Determination 2019/044

Regarding the code compliance of a domestic garage and driveway and the issue of a building consent and code compliance certificate for this work at 24 McLendon Green, Christchurch

Figure 1: Forward manoeuvre into the garage (Figure 3 from the experts' report)

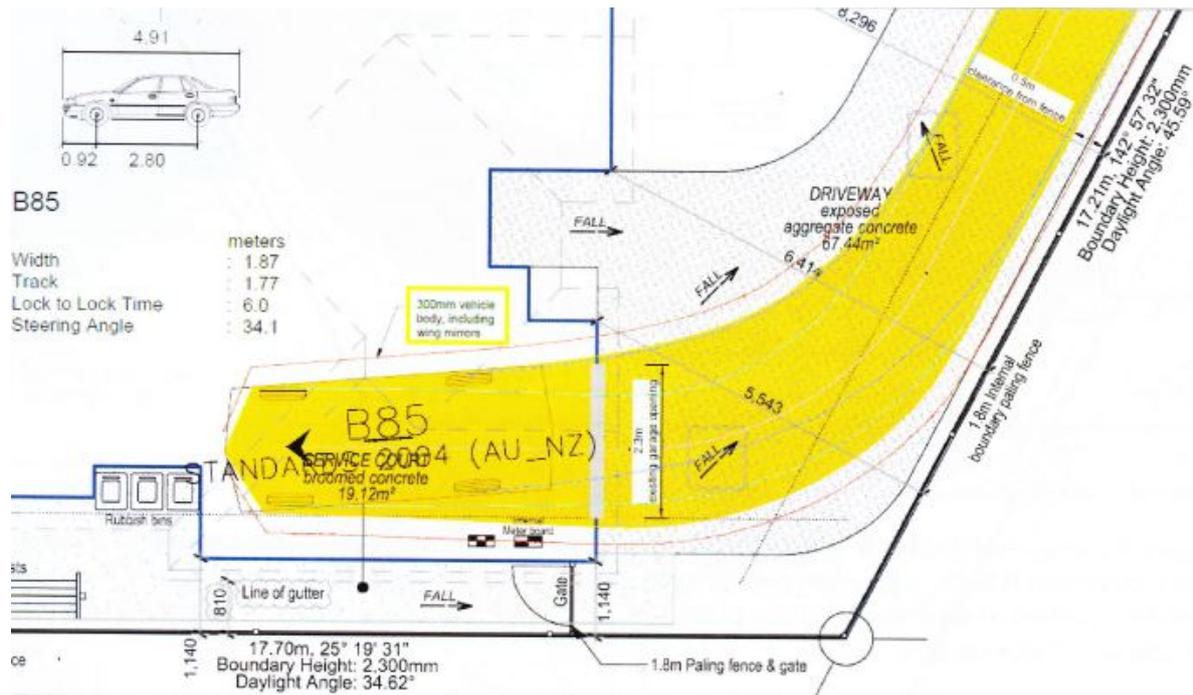
- 2.5 The following figures are taken from the experts' report. They show a car entering the garage, and a tracking curve for a vehicle entering the garage (refer to paragraph 5 of this determination for more explanation of these curves).

- 5.2.2 The experts said:
- driving the occupant's car into the garage currently required a three point turn
 - reversing this car out of the garage required a five point turn

- 5.2.3 The experts also used a computer program to ascertain whether the 85th percentile vehicle could enter the current as-built garage "easily", and how it could enter and exit this garage if the garage doorway was widened to 2.8 m. The computer program generated vehicle tracking diagrams which the experts overlaid on the consented plans. These diagrams showed the space that would be traversed by the body of an 85th percentile vehicle (i.e. by this vehicle and its wheels during a turn) as a shaded curved area. The diagrams also identified a 300 mm "clearance envelope" (marked as a red line) on either side of the shaded curve, which the experts said allowed for the vehicle's wing mirrors to clear obstacles and room for "imperfect driving".

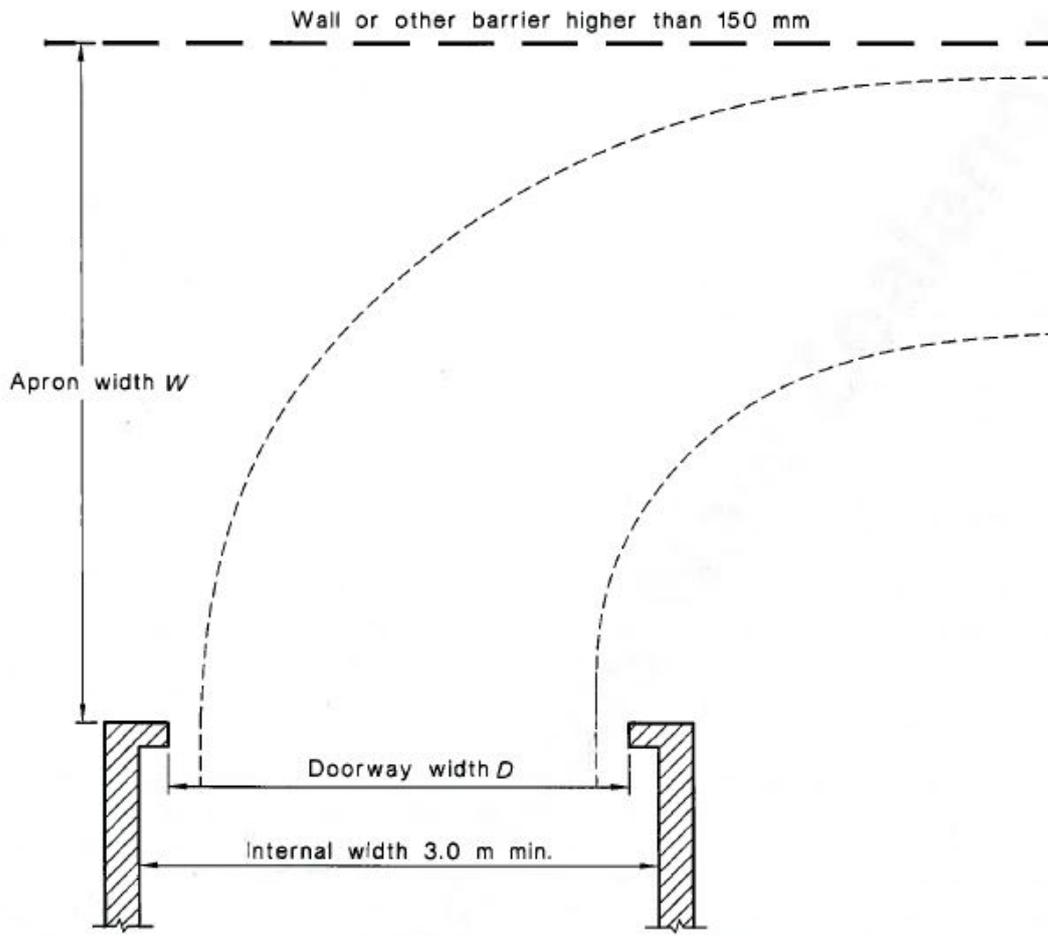
User class	...	Required aisle width	Examples of uses (note 1)
1		Minimum for single manoeuvre entry and exit	Employee and commuter parking (generally, all-day parking)
1A		Three-point turn entry and exit into 90° parking spaces only, otherwise as for User Class 1	Residential, domestic and employee parking
...
